NUREG/CR-4374
BNL-NUREG-51917
Vol. 2

A Review of the Oconee-3 Probabilistic Risk Assessment

External Events, Core Damage Frequency

Brookhaven National Laboratory

Figure 2.2 **Event tree for sequences initiated by turbine-building flooding.**
(OPRA Figure 9-77)

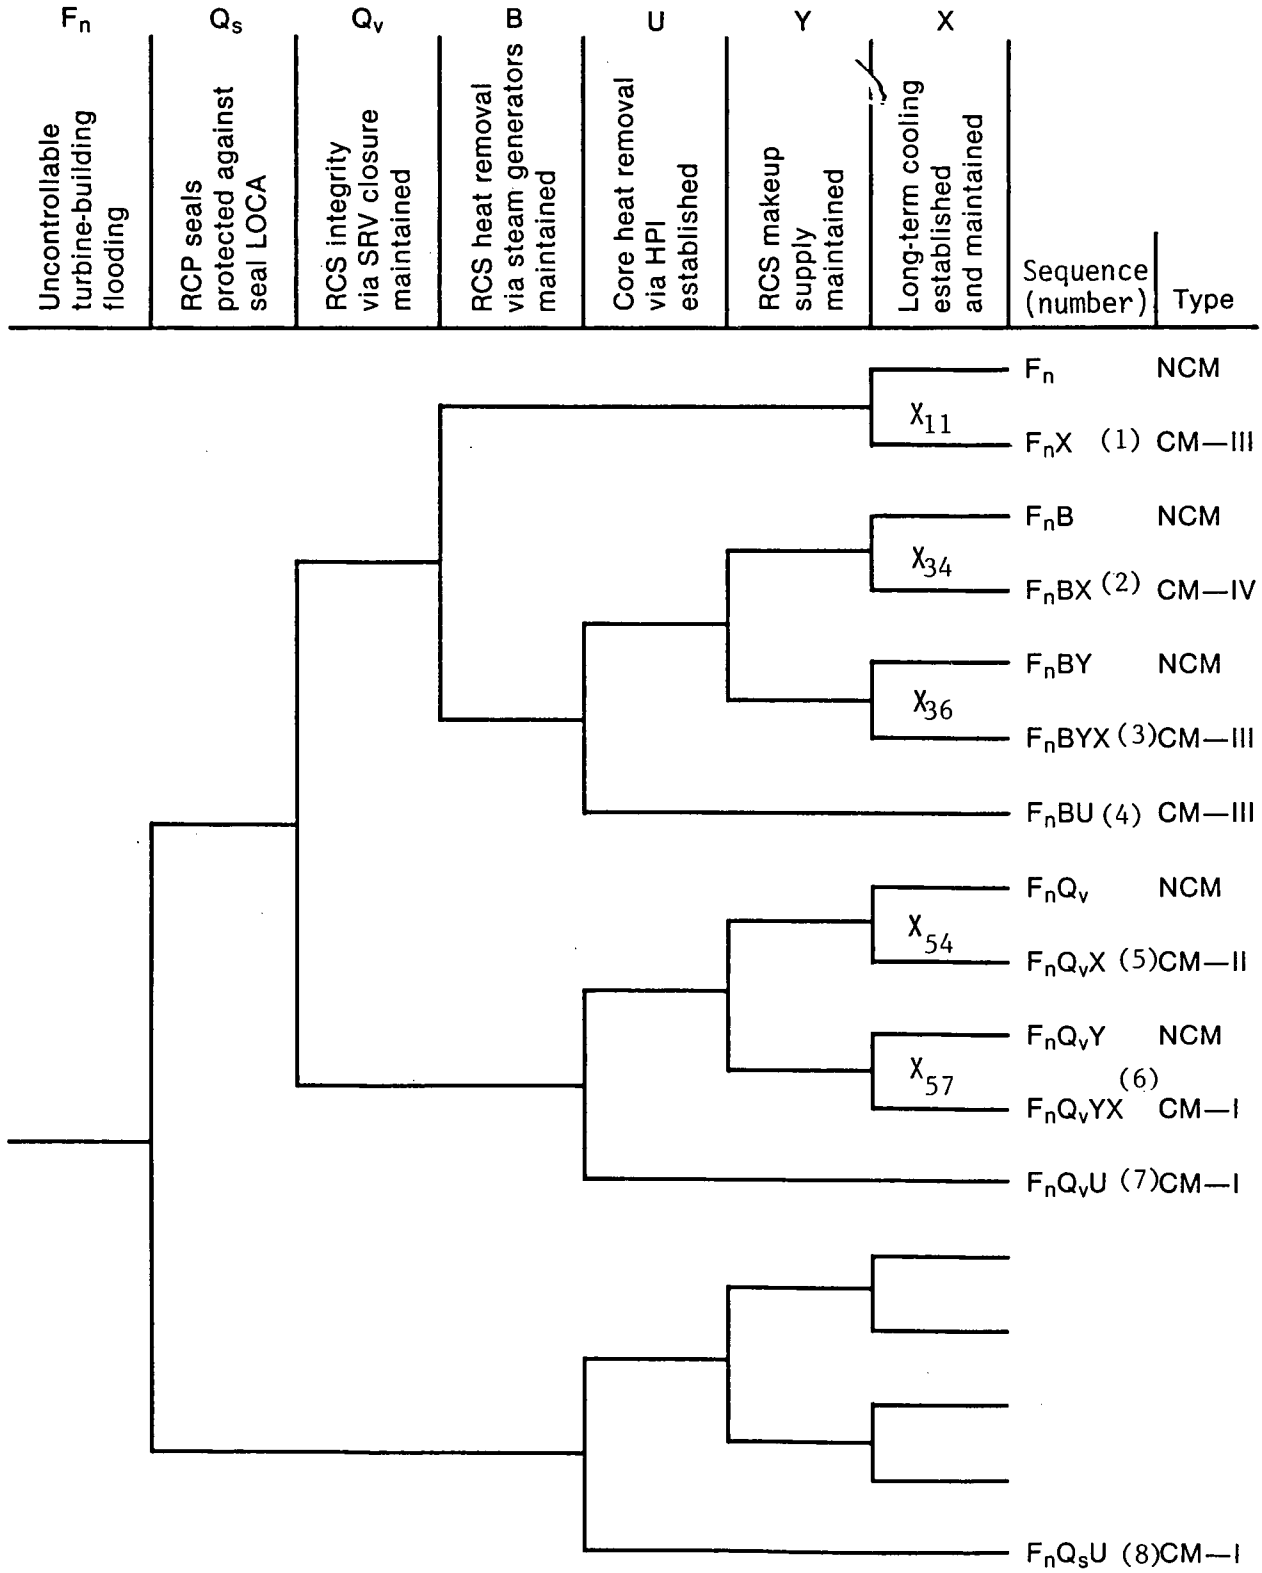
Eight event tree sequences initiated by a turbine building flooding are considered in the OPRA and are shown in Figure 2.2 (OPRA Figure 9-77); this review did agree with the event tree used in the OPRA.

BNL did not change the main accident sequences. However, a split between the short-term (~2 hours) and late (~12 hours) components of X36 and X57 (long-term cooling) is more realistic; this split was used in the BNL review. As a consequence of this split, sequence No. 6 contributes to bins I and II, and sequence No. 3 contributes to bins III and IV; the contributions to bins I and III are dominant, as presented in Appendix B. Note that the eight sequences in Figure 2.2 were used in the BNL quantification for each sequence. After the minimal cut sets in each segment were obtained with the SETS code, the splits of the sequences 3 and 6 were performed.

Figure 2.3 **Event tree for failure to maintain long-term SSF ASW suction after a flood.**
(OPRA Figure 9-93)

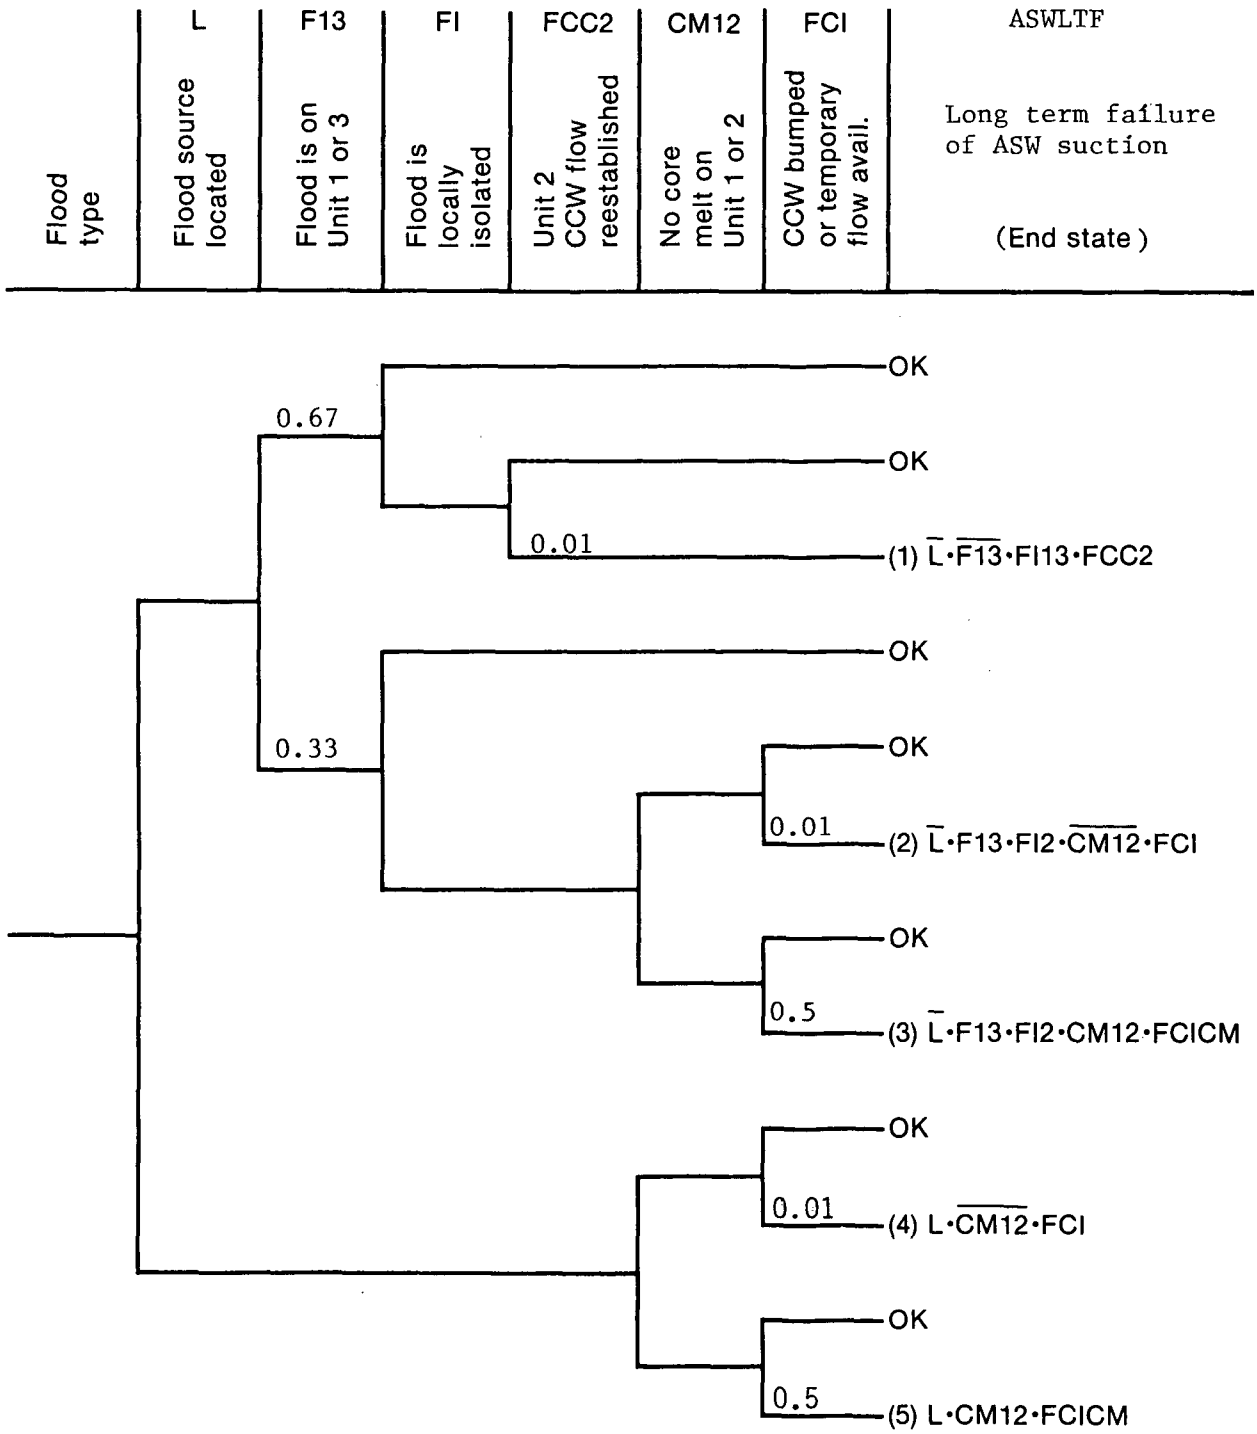
The "ASWLTF" is the result of the quantification of the event tree in Figure 9-93 of OPRA, shown in Figure 2.3 of this report. This figure, with the values given here in Table 2.7, can be used for its quantification. The ASWLTF is the conditional probability of losing ASW long-term suction given any flood initiator.

The above two operator actions are quantified in OPRA at 0.01. On the basis of this and BNL judgment, the third case of operator action of this type--establishing long-term suction to the ASW pumps--was also quantified by BNL at 0.01 (OPRA uses 5×10^{-3} for this in its quantification in Figure 9.93). This change is in part responsible for differences in the values of the BNL ASWLTF and the corresponding SFAPPS used in OPRA.

Figure 3.2 Oconee study seismotectonic model.

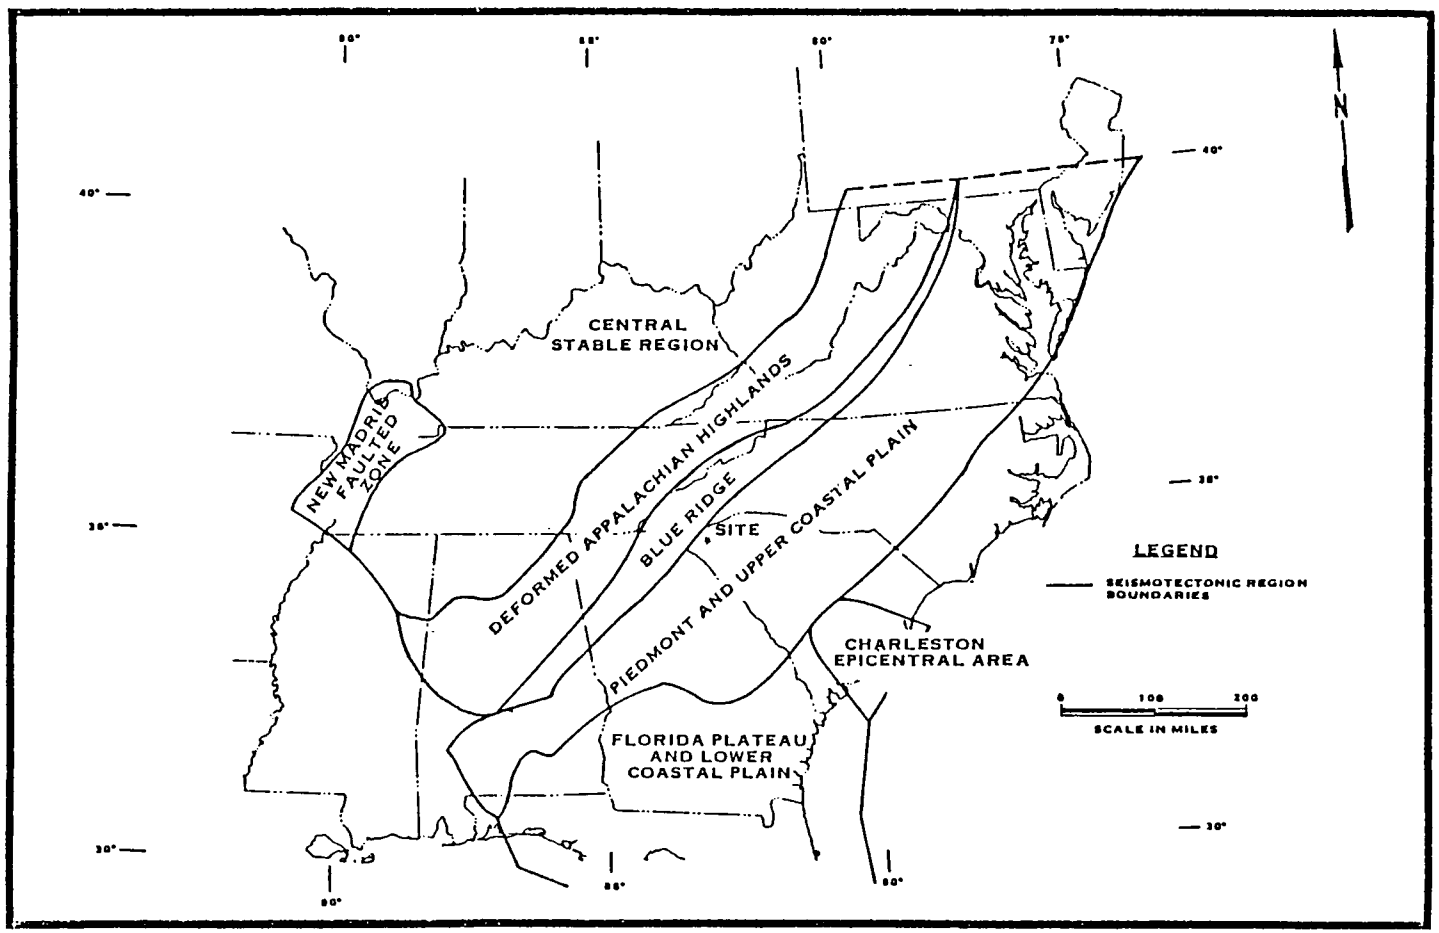
Figure 3.2 shows the seismotectonic model used in the OPRA to evaluate the ground motion hazard. This model was assigned a 1.0 weight, suggesting that there are no other realistic tectonic models that should be incorporated in the analysis or that all other relevant tectonic models are reasonably embodied in the model in Figure 3.2. The former view seems inappropriate, given that other studies available at the time[20-22] offer a number of alternative seismotectonic models. The latter view is a matter of practical concern since the only way to actually evaluate whether the results of other sources are implicitly included is to run the actual cases.

Figure 3.3 U.S. Geological Survey seismic sources near the Oconee site (Reproduced from Reference 21).

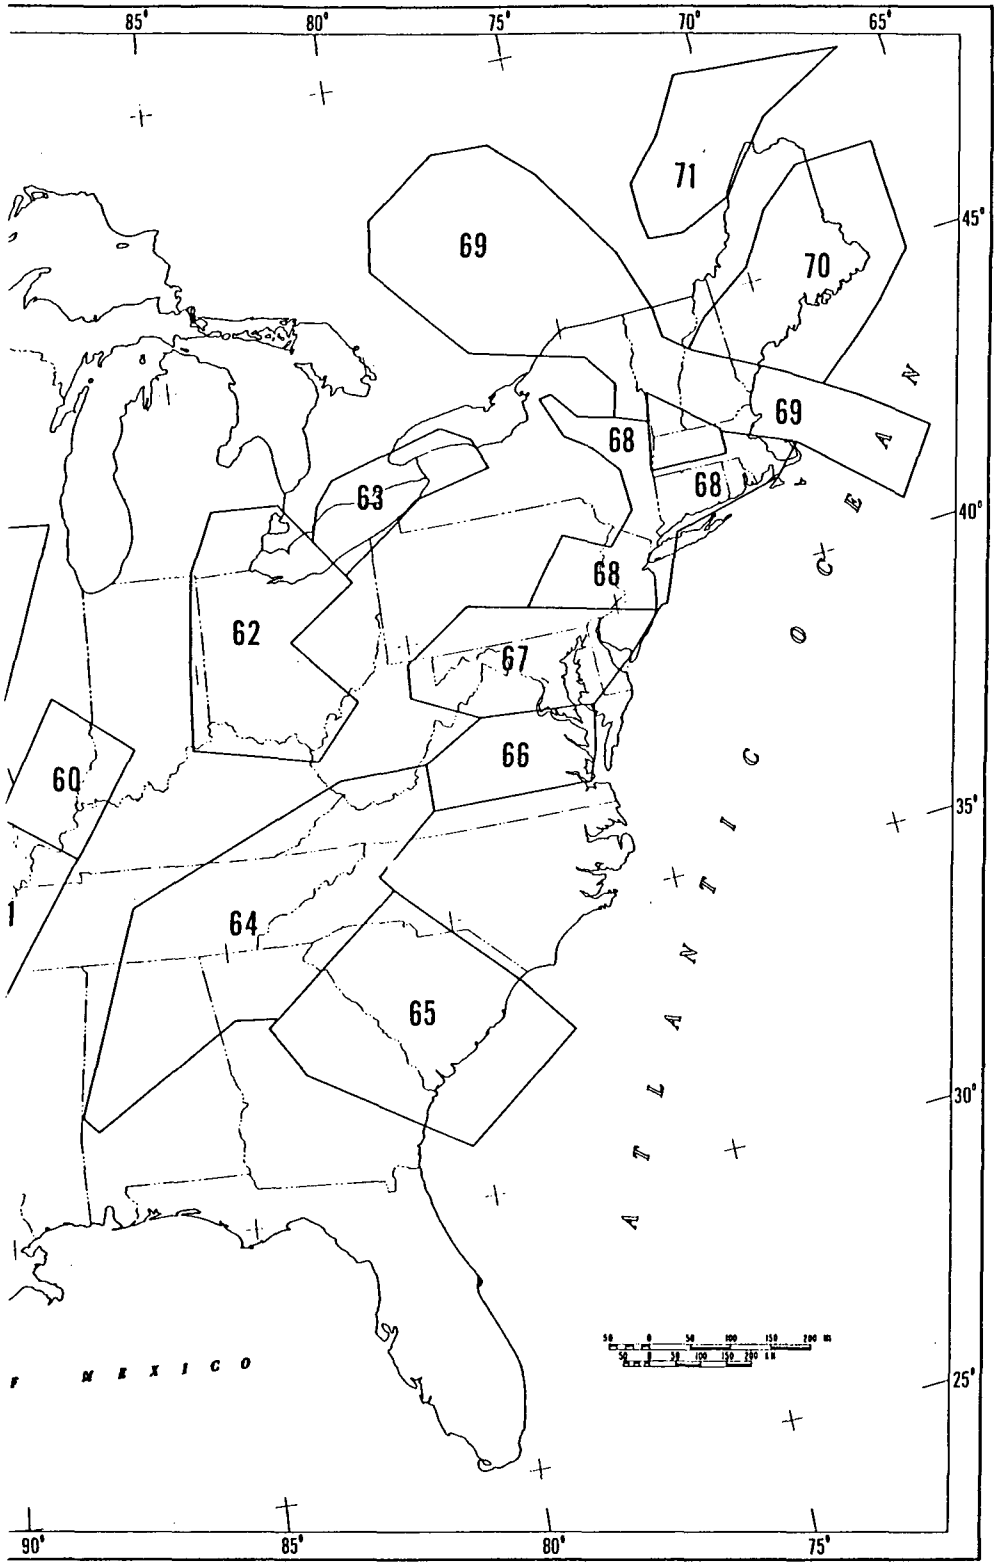
A comparison of the Oconee seismotectonic model with the 1976 USGS study[21] and the initial Lawrence Livermore National Laboratory seismic hazard study[20] was made. Figure 3.3 shows the USGS source areas used in their 1976 study. Relative to the seismic hazard at the plant, USGS source areas 64 and 65 represent an alternative seismotectonic model to that used in the Oconee study. One consequence of this model is the fact that the Charleston zone (No. 65) is considerably closer to the plant site. As a result, this model would allow Modified Mercalli Intensity X events to occur much closer to the plant. It is anticipated this would result in a higher estimate of the hazard at the plant.

In Figure 3.3 the USGS source areas in the vicinity of the Oconee plant are shown as defined in their 1976 study. The USGS zonation is considerably different from that used in the Oconee study. In fact they parallel closely the source areas suggested by Bollinger[22] (see Figure 3.6). In Table 3.4, the seismicity parameters for source areas 64 and 65 are reproduced from Reference 21. Recall that the 1976 study was completed before the Oconee analysis.

Figure 3.7 Comparison of the best estimate ground motion models from the LLNL ground motion panel for magnitudes 5 and 7 and the Oconee attenuation relationships.

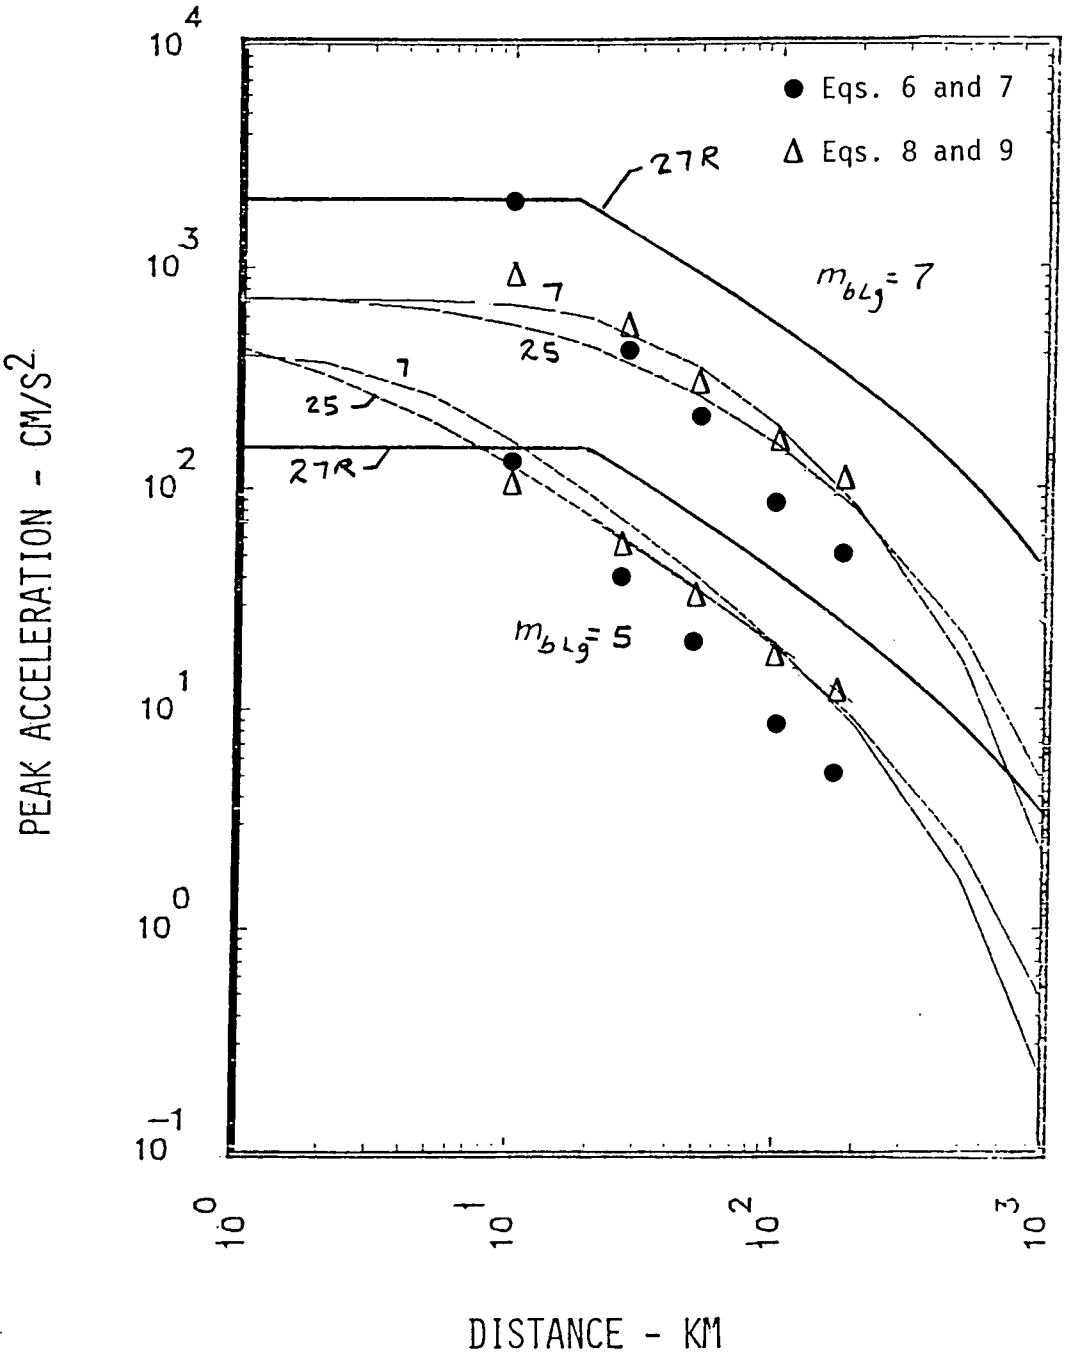
In Figure 3.7, the two attenuation models used in the Oconee study are compared to the best-estimate ground motion models (for rock) selected by the experts in the SHCP[5]. To plot the curves, the relationship, MMI = 2 M_b-3.5 was used to convert MMI to magnitude. Figure 3.8 presents a similar comparison with other models provided by the ground motion experts.

Figure 3.8 Comparison of the Oconee attenuation models and other models provided by the SHCP ground motion experts.

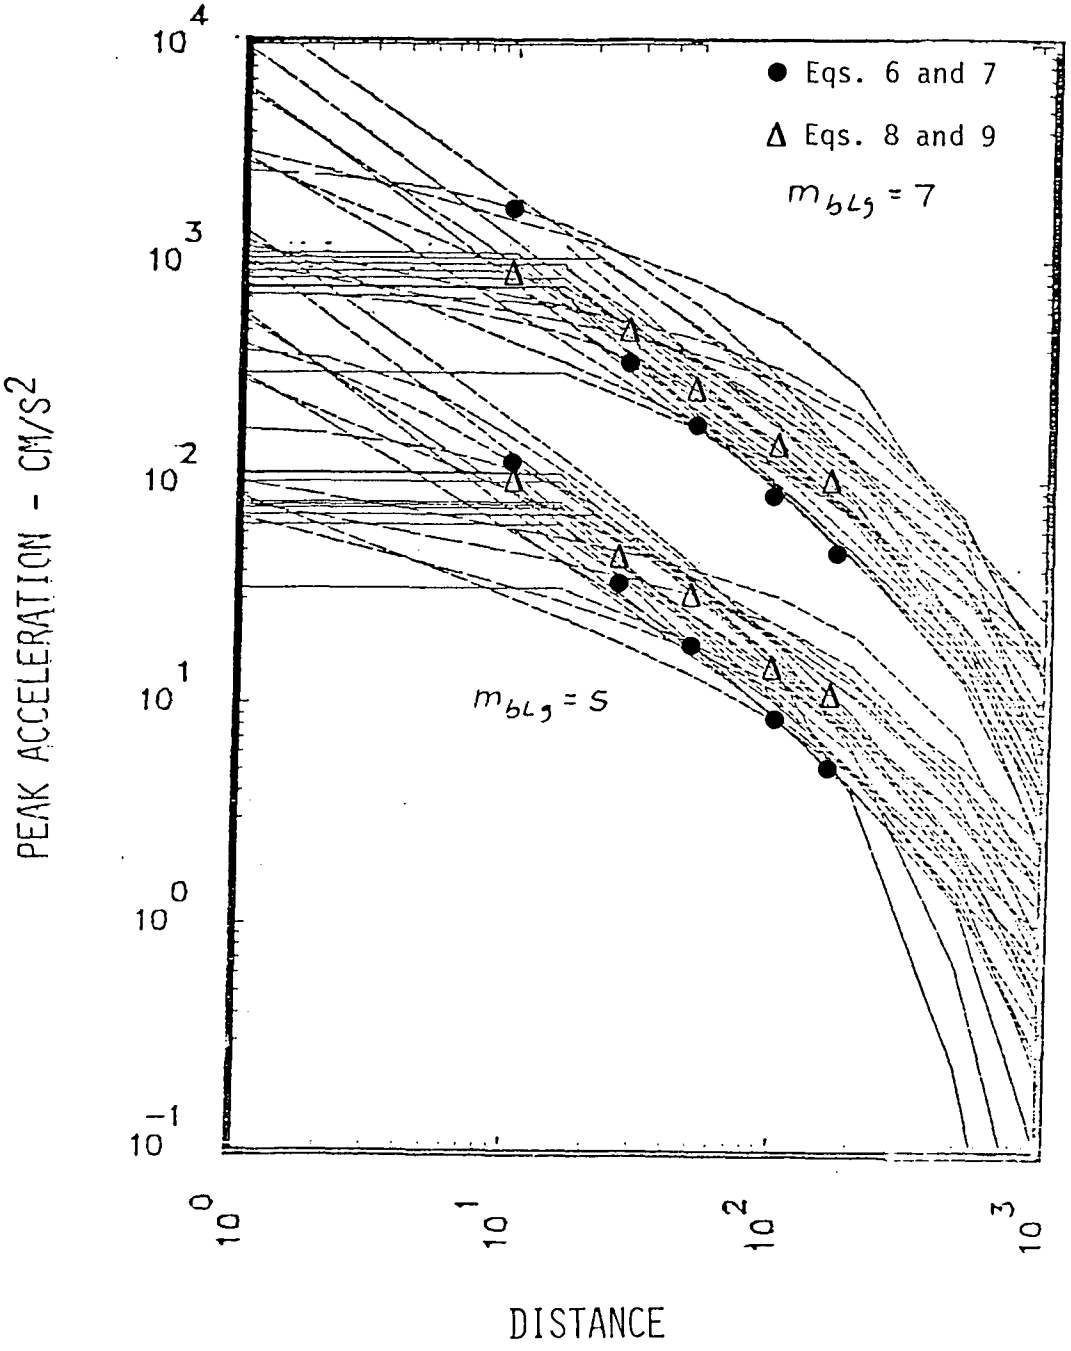
Figure 3.8 provides a different comparison. In this figure it can be seen that considerable variability can exist in the assessment of ground motion. In particular, the Oconee study incorporates only a part of this variability. A site-specific analysis, however, may not be expected to have as large a variability as a regional study, such as the SHCP. However, as shown in Figure 3.8 for magnitude 7.0, where the dispersion among the experts is great, the Oconee study accounts for only a fraction of the total variation.
